Subject: CI-SRP-7.A-SRSB-03, Markup of DCD Revision 18, Chapter 15-Section 15.4.2

Enclosure 1 provides a markup of Section 15.4.2 of the DCD which has been modified to satisfy the requirements identified in CI-SRP-7.A-SRSB-03.

CI-SRP-7.A-SRSB-03, Markup of DCD Revision 18, Chapter 15

15.4.2 Uncontrolled Rod Cluster Control Assembly Bank Withdrawal at Power

Figure 15.4.2-14

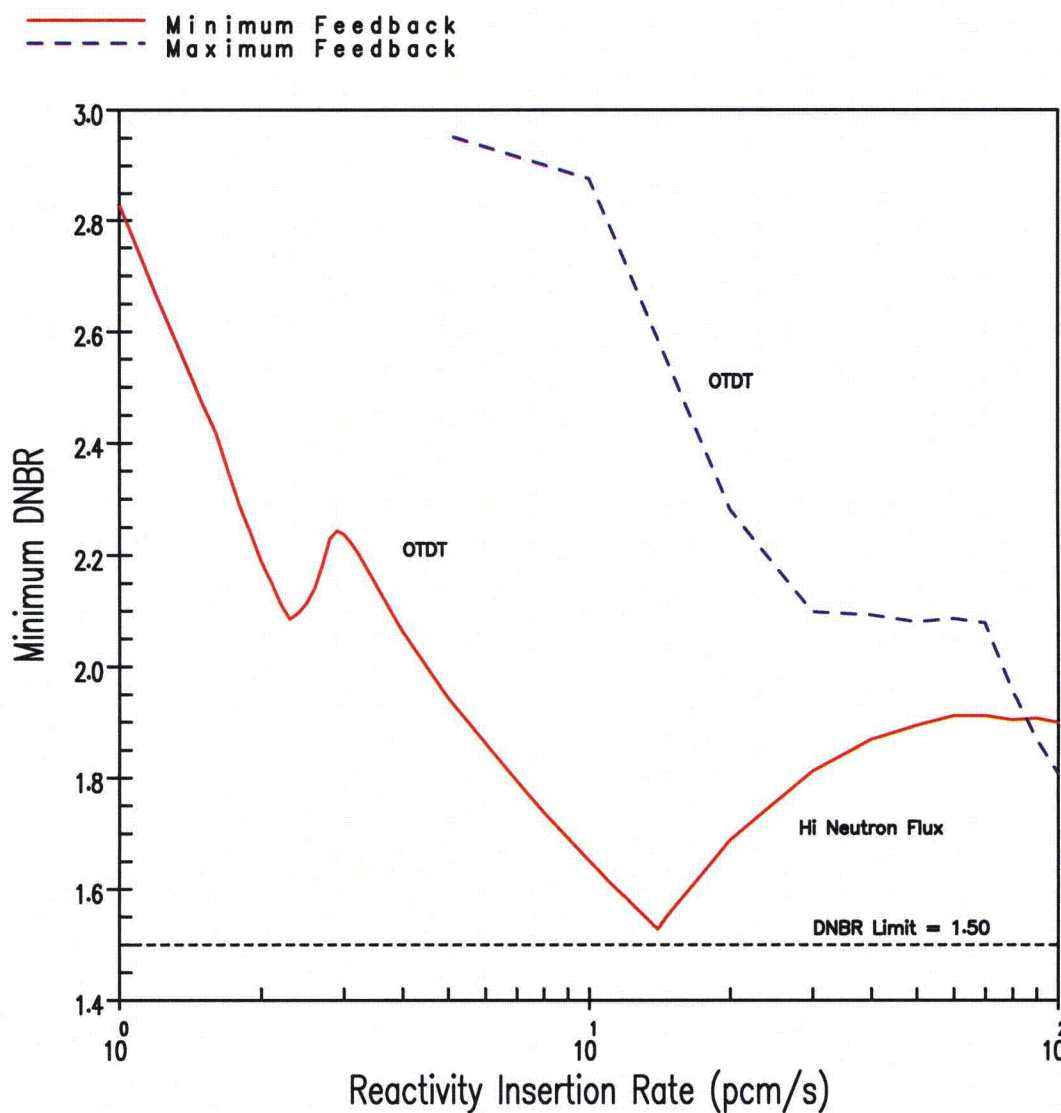
Figures 15.4.2-14 and 15.4.2-15 show the minimum DNBR as a function of reactivity insertion rate for RCCA bank withdrawal incidents for minimum and maximum reactivity feedback, starting at 60-percent and 10-percent power, respectively. Minimum DNBR occurs immediately after rod motion and before the loss of offsite power. The results are similar to the 100-percent power case, except as the initial power is decreased, the range over which the overtemperature ΔT trip is effective is increased and for the maximum feedback cases the transient is always terminated by the overtemperature ΔT reactor trip. The DNB design basis described in Section 4.4 is met.

Referring to Figure 15.4.2-14, for example, it is noted that for transients initiated from 60-percent power:

- A. For high reactivity insertion rates above 14 pcm/s, reactor trip is initiated by the high neutron flux trip for the minimum reactivity feedback cases. Reactor trip is initiated by overtemperature ΔT for the whole range of reactivity insertion rates for the maximum reactivity feedback cases. For minimum reactivity feedback cases, the neutron flux level in the core rises rapidly for the higher reactivity insertion rates while core heat flux and coolant system temperature lag behind due to the thermal capacity of the fuel and coolant system fluid. Thus, the reactor is tripped prior to a significant increase in heat flux or water temperature with resultant high minimum DNBRs during the transient. As reactivity insertion rate decreases, core heat flux and coolant temperatures remain more nearly in equilibrium with the neutron flux. Thus, minimum DNBR during the transient decreases with decreasing insertion rate.

- C. For reactivity insertion rates less than approximately 40 pcm/s for the minimum feedback cases, the rise in reactor coolant system pressure is sufficiently high that the pressurizer safety valve setpoint is reached prior to reactor trip. Opening of this valve limits the rise in reactor coolant pressure as the temperature continues to rise. Because the overtemperature ΔT reactor trip setpoint is based on both temperature and pressure, limiting the reactor coolant pressure by opening the pressurizer safety valve brings about the overtemperature ΔT earlier than if the valve remains closed. For this reason, the overtemperature ΔT setpoint initiates reactor trip at reactivity insertion rates of approximately 14 pcm/s and below for the minimum feedback cases. For the maximum feedback case, the pressurizer safety valves open prior to reactor trip for reactivity insertion rates as high as 110 pcm/s.

- D. For the minimum feedback case, at reactivity insertion rates less than approximately 14 pcm/s the overtemperature ΔT trip predominates and the effectiveness of the overtemperature ΔT trip increases (in terms of increased minimum DNB) because for these lower reactivity insertion rates, the power increase is slower, the rate of rise of average coolant temperature is slower, and the system lags and delays become less significant.

- E. For reactivity insertion rates less than approximately 3 pcm/s for the minimum feedback cases and less than approximately 70 pcm/s for maximum feedback cases, the rise in the reactor coolant temperature is sufficiently high so that the steam generator safety valve setpoint is reached prior to trip. Opening of these valves, which act as an additional heat load on the reactor coolant system, sharply decreases the rate of increase of reactor coolant system average temperature. This decrease in the rate of increase of the average coolant system temperature during the transient is accentuated by the lead-lag compensation. This causes the overtemperature ΔT setpoint to be reached later, with resulting lower minimum DNBRs.
